Access Compliance Report Public Rights-of-Way (RR Crossings)

Intersection ID: 13736	Main Street: CAMDEN_RD	Location: N/A
ADA ID: 132151AFCC41	Overall Compliance: No	Severity Score: 0.0
Codes/Mitigation Info/Possible Solution		Field Measurements/Component Compliance

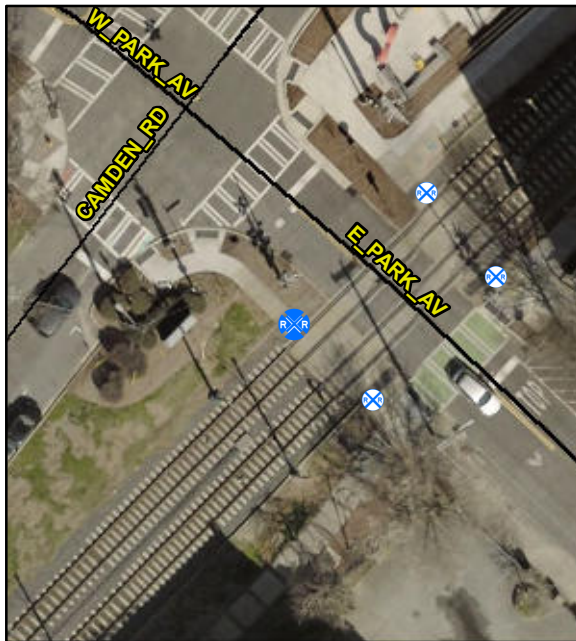
**Remove & Replace Detectable
Warning System. Provide Pedestrian
Gate. Remove & Replace Walking
Surface Adjacent to Rail.**

R302.7.4, R305.2.5

Compliance	Description	Data
Yes	DWS Provided?	Yes
Yes	DWS Contrast?	Yes
Yes	DWS Width (in)	Yes
Yes	DWS Length (in)	36.0
No	DWS Offset (in)	29.0
No	Pedestrian Gate?	No
N/A	DWS Outside Gate?	No
N/A	Rail Type?	LightRail
No	Flangeway Gap (in)	3.0
Yes	Sidewalk Width (in)	59.0
